Project	IEEE 802.16 Broadband Wireless Access Working Group < http://ieee802.org/16 >	
Title	Downlink Burst Profile Synchronization for MSS in Sleep Mode	
Date Submitted	[2004-11-14]	
Source(s)	<p>Jungje Son, Jaeweon Cho, Changhoi Koo Samsung Electronics 416, Maetan-3dong, Youngtong-gu, Suwon-si, Gyeonggi-do, Korea</p> <p>Vladimir Yanover Alvarion Ltd. 21 A Habarzel St. Ramat - Hahayal Tel - Aviv 69710 P.O. Box 13139, Tel-Aviv 61131, Israel</p>	<p>Voice: [+82-31-279-5098] Fax: [+82-31-279-5130] mail to: jungje.son@samsung.com, jaeweon.cho@samsung.com, chkoo@samsung.com</p> <p>Voice: [+972-36457834] Fax: [+972-36456222] mail to: vladimir.yanover@alvarion.com</p>
Re:	This contribution is for reply of IEEE802.16e/D5 recirculation.	
Abstract	This contribution proposes the synchronization scheme of downlink burst profile for MSS in sleep mode.	
Purpose	Discussion and Adoption in IEEE 802.16e	
Notice	This document has been prepared to assist IEEE 802.16. It is offered as a basis for discussion and is not binding on the contributing individual(s) or organization(s). The material in this document is subject to change in form and content after further study. The contributor(s) reserve(s) th

Fig. 1. DIUC mismatch due to the change of DCD message

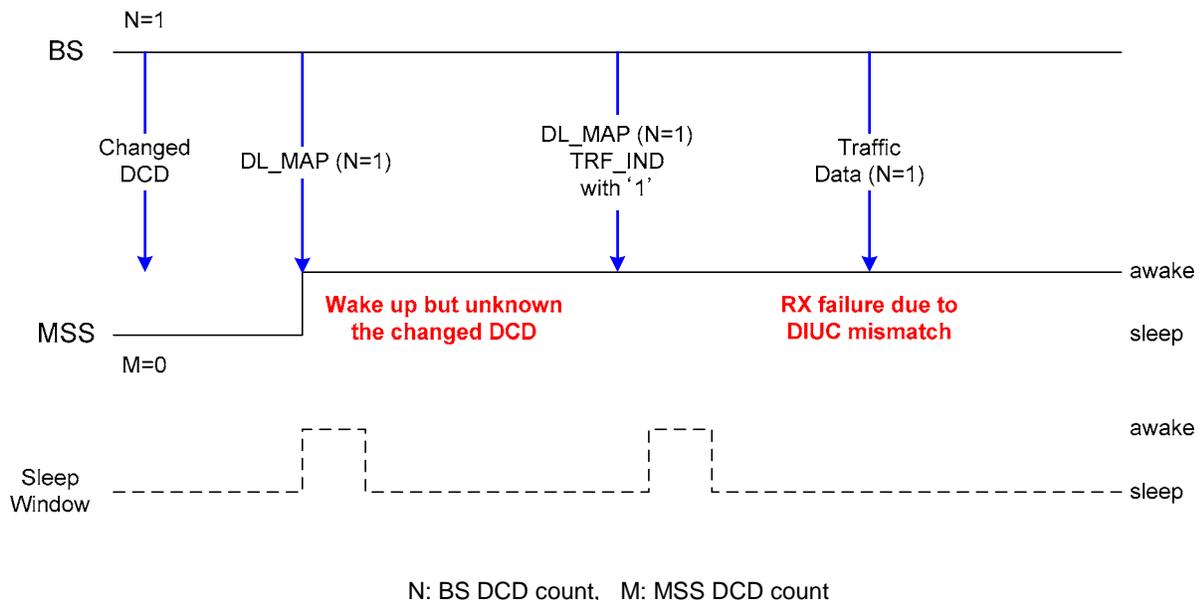
If BS transmits the new DCD message during sleep-window of a MSS, the MSS is not aware of the change of DCD message. Even though the MSS entering listening-window perceives the DCD change by receiving DL-MAP message, if BS transmits the data burst with the DIUC defined in the new DCD message, DIUC mismatch can occur. Hence, the transmitting data burst can be lost. Such DIUC mismatch case is depicted in Fig. 1.

In this contribution we propose new MAC header with which MSS can report the burst profile change during Sleep Mode. The proposed MAC header includes the same fields of DCD count change and DIUC update as in RNG-REQ message [\(in Suggested Remedy 2\)](#), and includes the received CINR at MSS and the DCD Change Indication [\(in Suggested Remedy 3\)](#). ~~but~~ Its size is equal to that of Bandwidth Request Header. When MSS receives MOB-TRF-IND Message with positive indication and also UL allocation for its confirmation, the MSS can send the proposed MAC header instead of Bandwidth Request Header. By using the proposed MAC header, MSS can inform BS of the DCD ~~count~~ change and/or DIUC update and also the signaling overhead for sending REQ-REQ message can be avoided.
